APPLICATION FOR A RESIDENTIAL SITE IMPROVEMENT PERMIT/ CONSTRUCTION AUTHORIZATION FOR AN ON-SITE WASTEWATER SYSTEM, NEW WELL INSTALLATION, OR REPAIR OF EXISTING WELL

Residential Subsurface Wastewater Treatment and Disposal System Design

5201 Mintridge Road
Charlotte, North Carolina

Tax Parcel # 195-031-36
Mecklenburg County File # 1789B
May 15, 2009

SHEET 1 OF 1

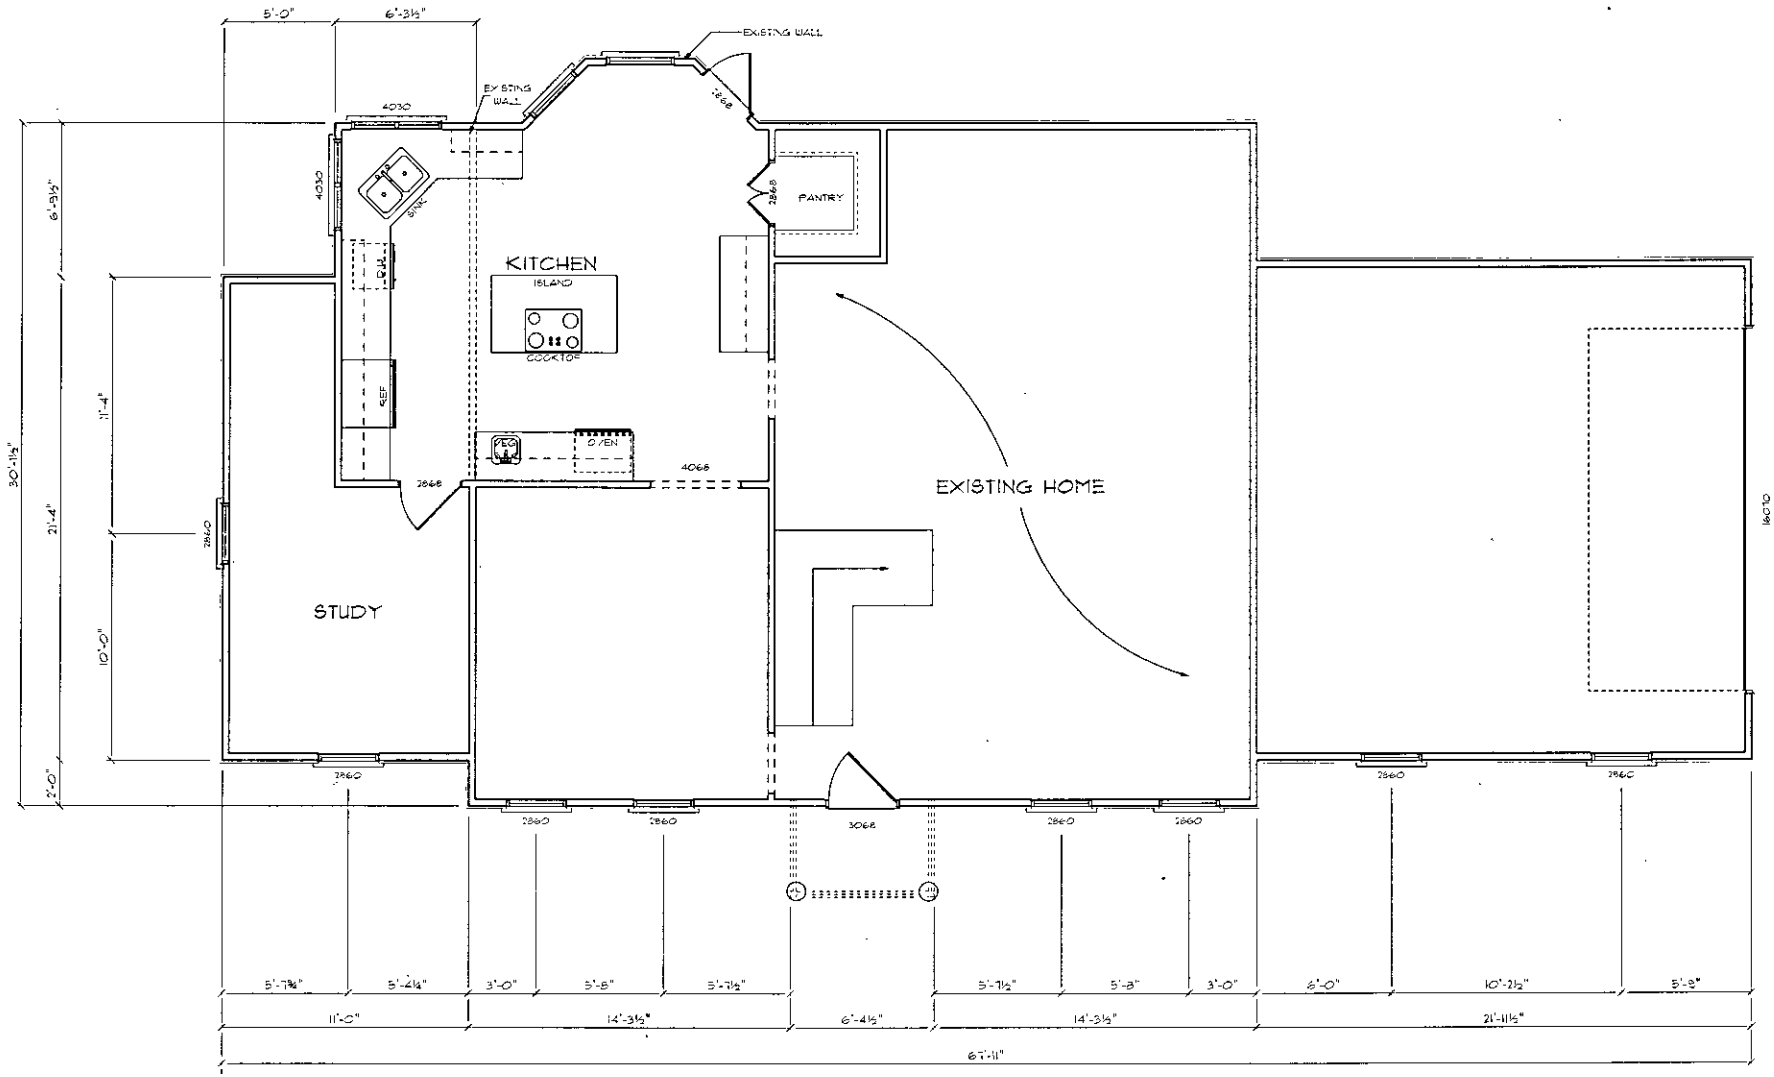
The existing conventional drainlines (3 – 3-foot wide x 133-foot long) have been located and it has been determined that one of the three drainlines (the drainline closest to the residence) must be abandoned due to its proximity to the existing screened-in porch as well as the proposed addition. We propose to remove the existing deck and cantilever the existing screened-in porch to allow for the required setback from the next closest drainline (Mr. Paul Barlow of Paul Barlow Builders has confirmed that the porch can be cantilevered). The foot print of the proposed addition has been altered as well to allow for the required 5-foot separation between the addition and the next closest drainline.

TEC proposes to replace the storage that will be lost by cutting off the drainline that is located closest to the residence and adding (2) 3-foot wide x 50-foot long Infiltrator Chamber drainlines in the front yard. The new drainlines will be feed by gravity from the existing distribution box and a flow divider will be used to split the flow equally at the head of the new trenches.

Install Per Plot Plan
Designed by Larry Thompson LSS

PROPOSED PLOT PLAN

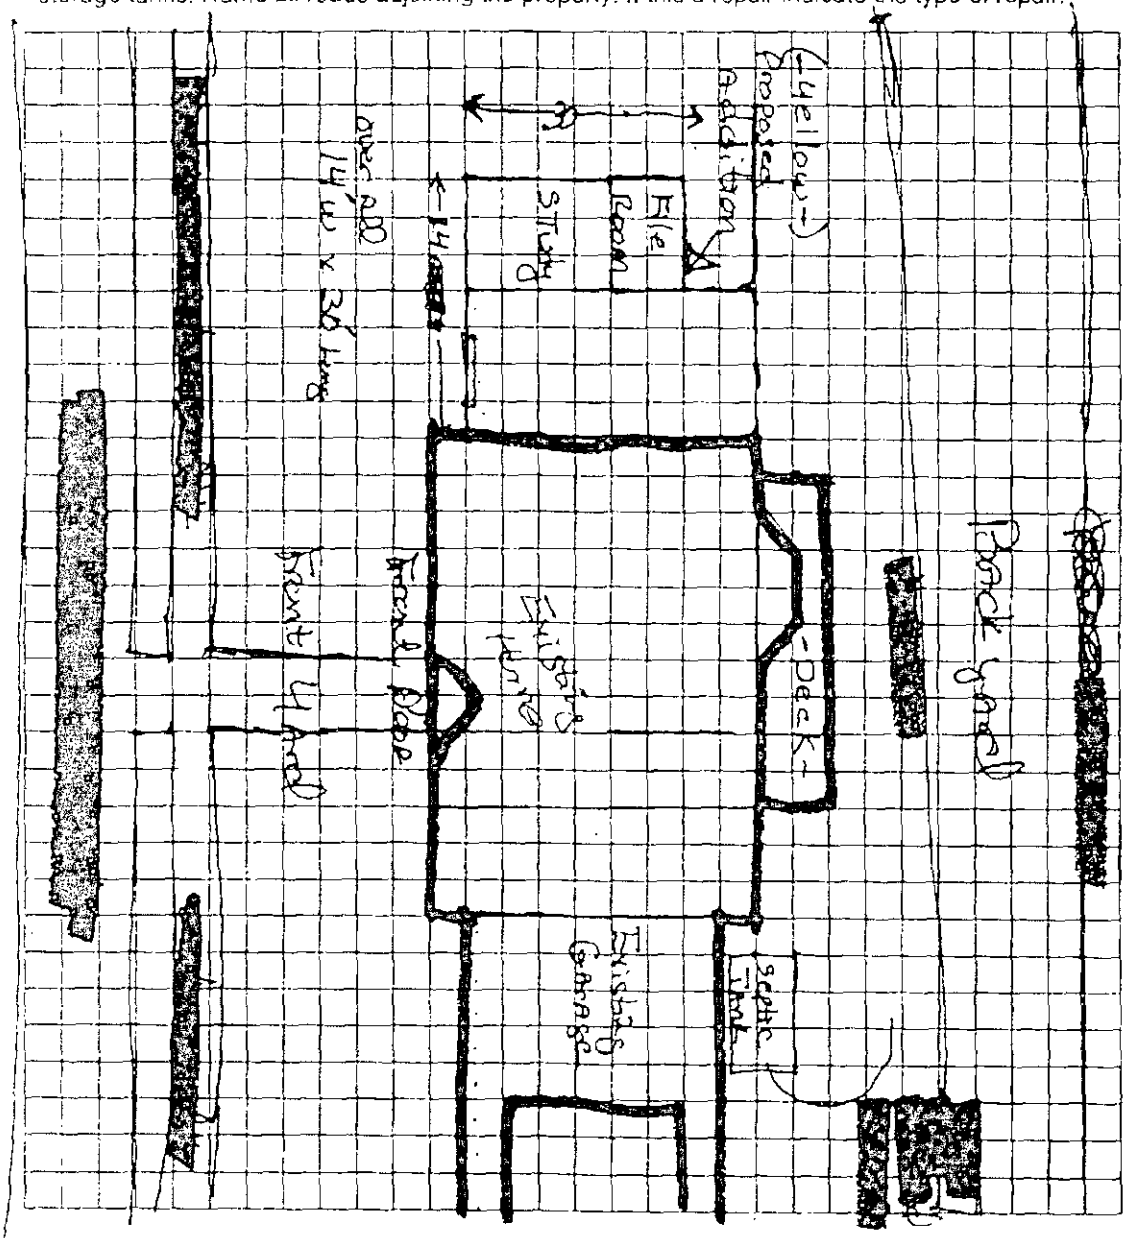
Proposal Does not meet Setbacks off drainfield - Use existing Denied
Jeremy Mikel 4-9-09
EHS Signature — Date

- ☐ The existing on-site wastewater treatment & disposal system was not functioning properly at the time the site evaluation was conducted.
- ☒ The proposed plans do not meet the required setbacks for the on-site wastewater treatment & disposal system serving the property.
- ☐ The proposed plans do not meet the required setbacks for the reserved repair area for an on-site wastewater treatment & disposal system.
- ☐ The proposed plans do not meet the required setbacks for water supply wells.
- ☐ The proposed project will exceed the permitted daily design flow for the existing on-site wastewater treatment & disposal system. System alteration will be required in order to accommodate your proposed project.

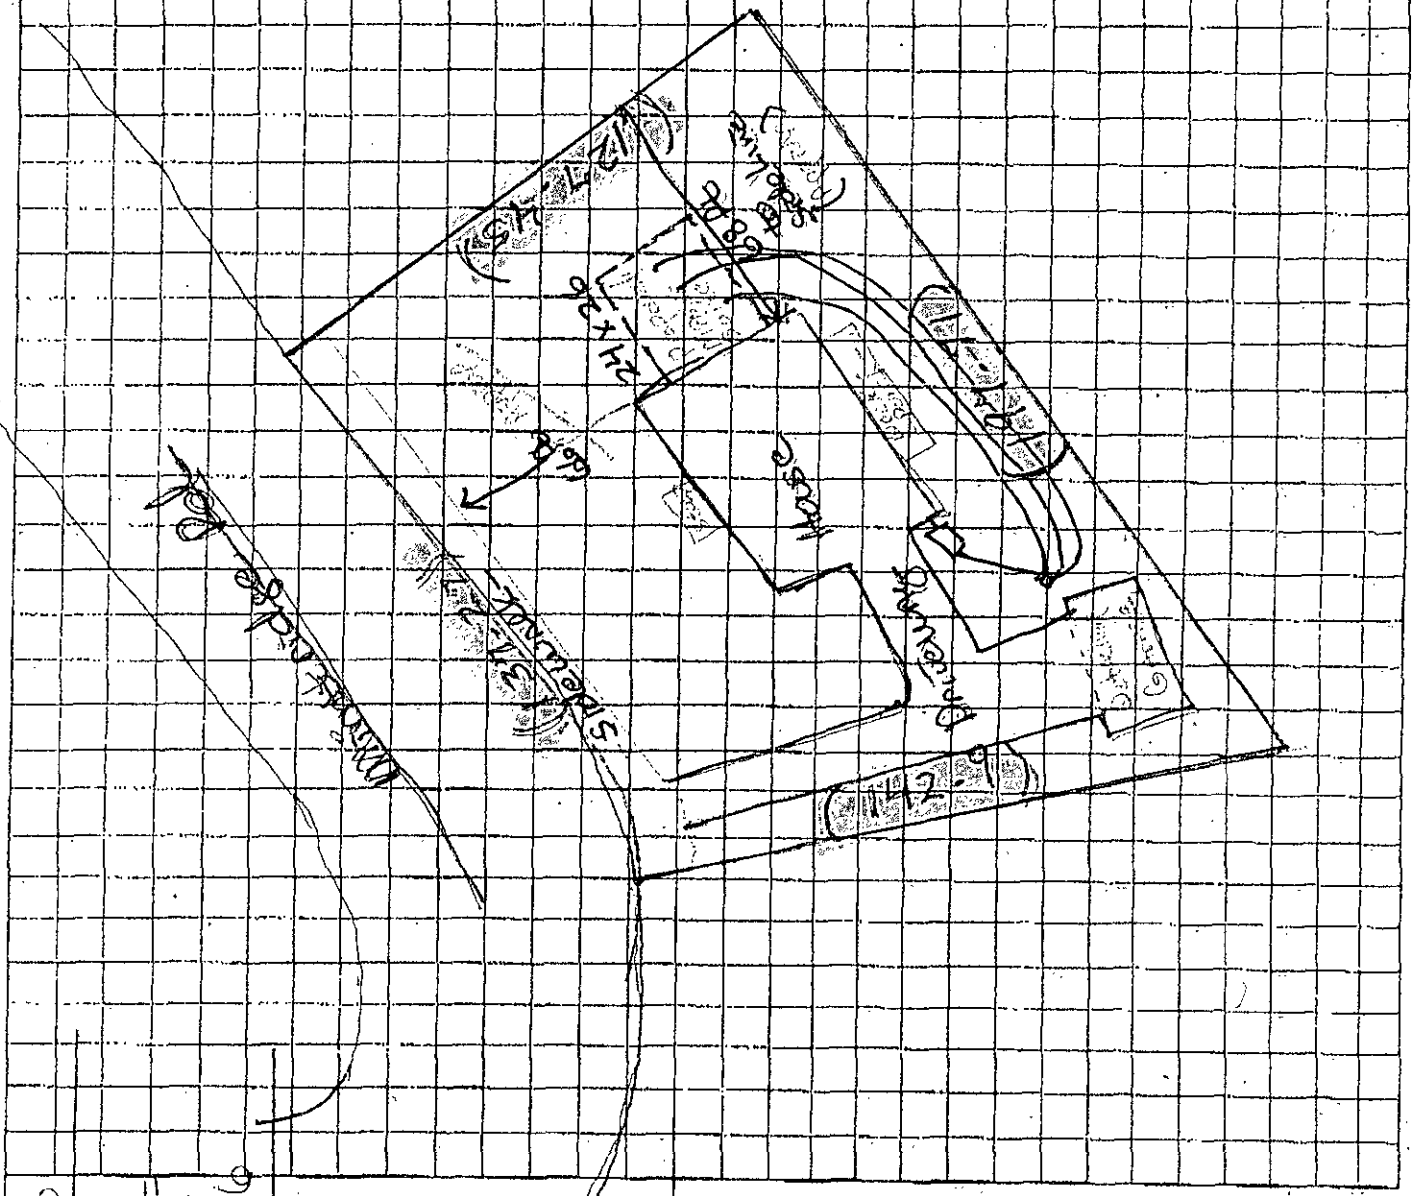
Bedroom & bathroom addition
Denied
Phila A. Walker RS 2/1/06
EHS Signature Date

Drainfield extends into proposed bedroom area
